Access Compliance Report Public Rights-of-Way (Curb Ramps)

Main Street: ORANGE_AVE Cross Street: THISTLE_RD Location: NW

ADA ID: RPAT211130140832 Ramp Type: Type 1 - Perpendicular Diagonal Initial Pass/Fail: Pass Overall Compliance: No Severity Score: 0

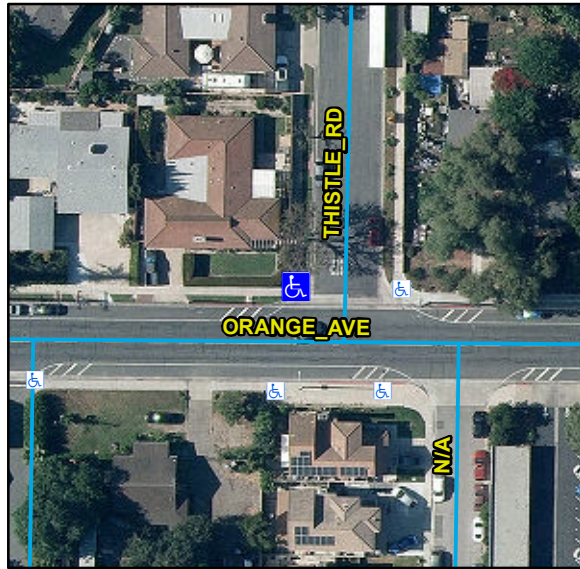
Remove & Replace Landing.

R304.2.1, STD 1115
